**Re: Level One Hydrogeologic Assessment - Updated**
**Redmond Town Center**
**Proposed Parcel Redmond 5B Development**
**Redmond, Washington**
19162-01

**Re: Level II Hydrogeologic Assessment**
**Temporary Construction Dewatering Feasibility Assessment**
**Redmond Town Center**
**Redmond 5B**
**Redmond, Washington**
19162-01

**Re: Level II Hydrogeologic Assessment**
**Temporary Construction Dewatering Feasibility Assessment**
**Redmond Town Center**
**Proposed Parcel 5B Development**
**Redmond, Washington**
19162-01

**Site and Dewatering Plan**

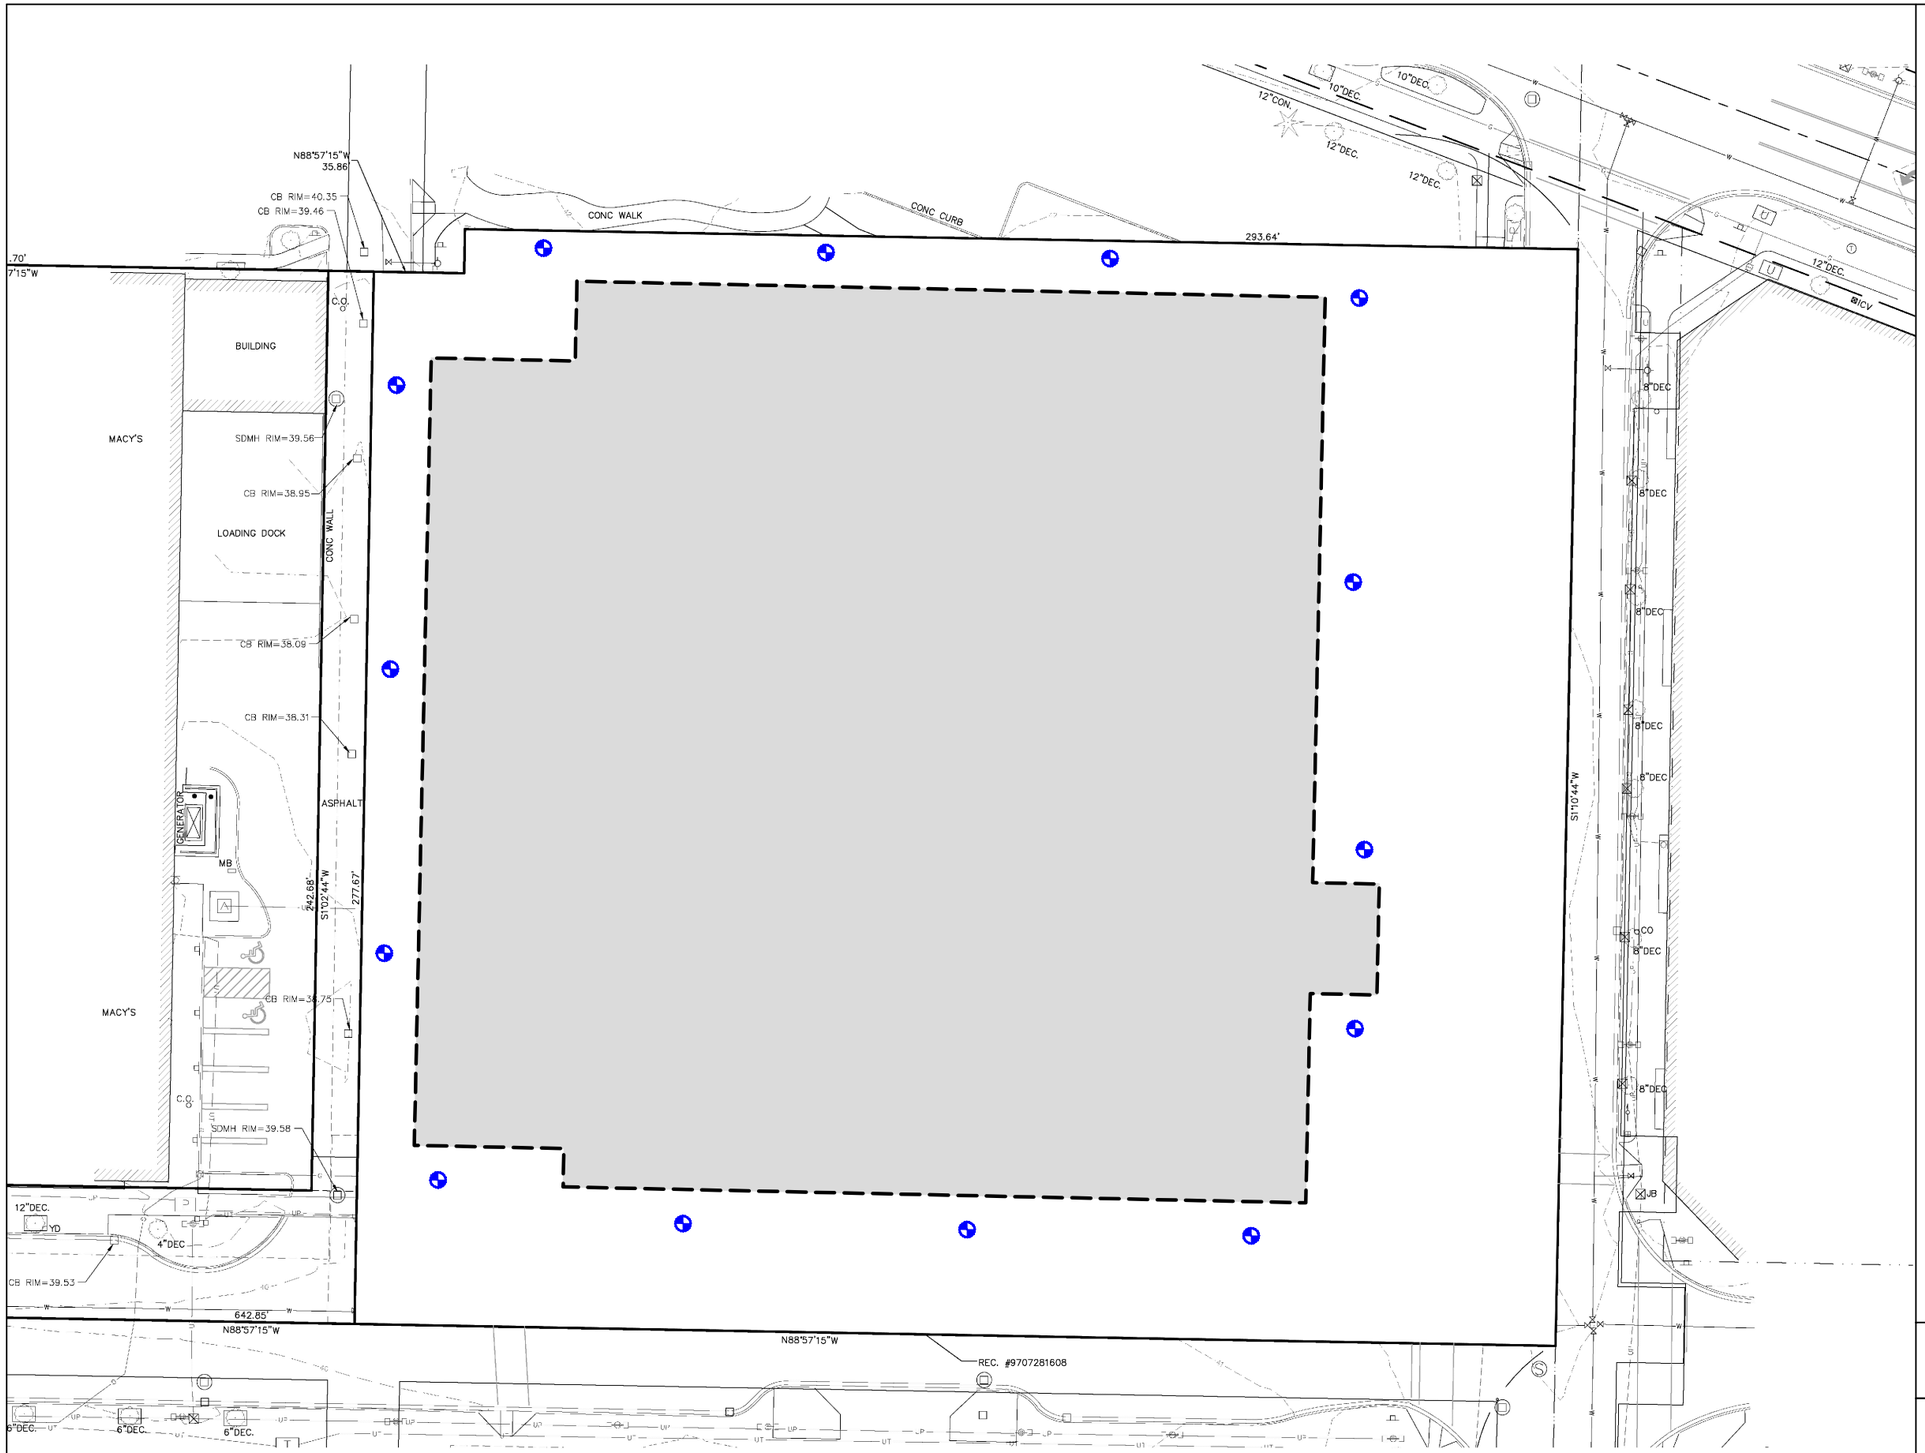
### Provide a preliminary figure showing number and depth of well points, or equivalent.

The project will be dewatered using a series of large-diameter wells installed around the perimeter of the excavation. The well spacing will range from 50 to 100 feet. Figure 2 shows potential locations of wells.

Figure **3**

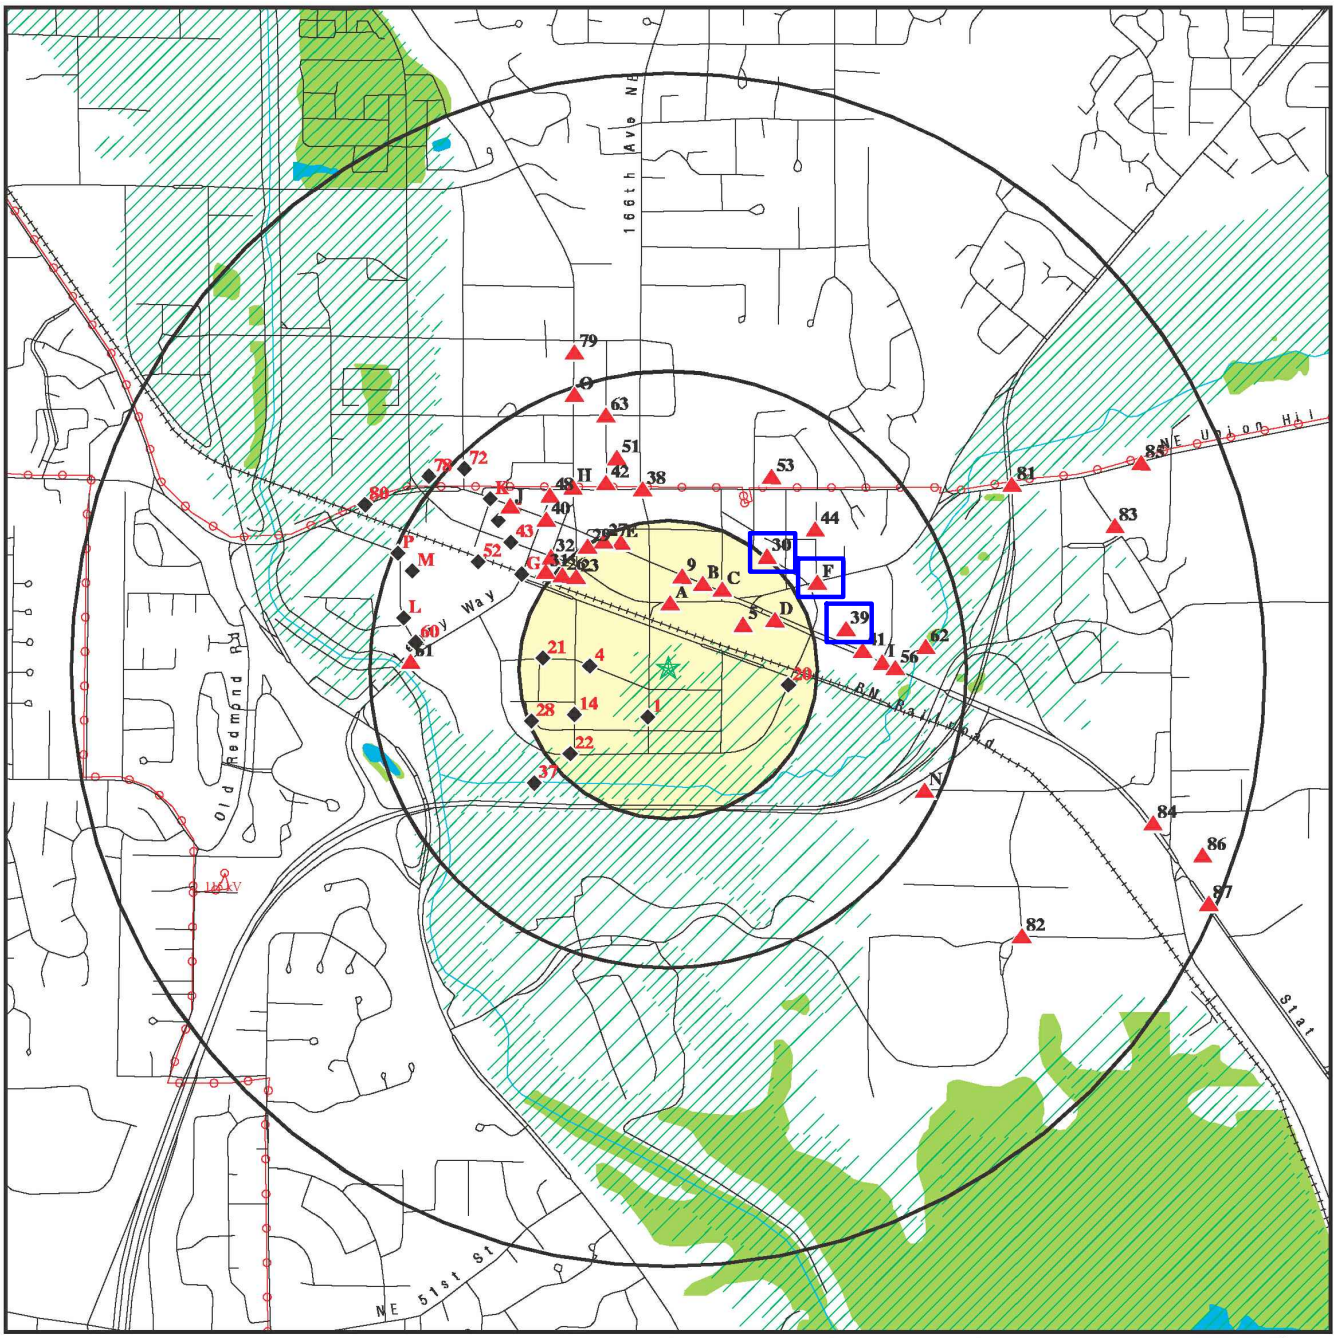
### Review available environmental assessments and geotechnical data to determine whether groundwater contamination may adversely affect dewatering. (Part of your inquiry should include contacting Natural Resources for insight into contaminants in the vicinity of the project site.)

Hart Crowser (2015a) reviewed the regulatory databases and reports to identify adjacent and surrounding sites that were within 1 mile of the project site and (1) were in the apparent upgradient or cross-gradient groundwater flow direction of the project site, (2) had reported releases of contaminants to soil and/or groundwater, and/or (3) were listed as historical auto stations or dry cleaners. Table 3 (at end of text) is a list of sites posing environmental concerns within 1 mile of the project site. The site

locations are shown on Figure 3. Sites to the northeast are generally hydrologically upgradient of the project site. In our opinion, dewatering at the project site will not increase the footprint of groundwater contamination originating from (1) sites downgradient or cross-gradient of the project site, (2) sites with no groundwater contamination noted, or (3) sites Ecology has granted no further action (NFA) status.
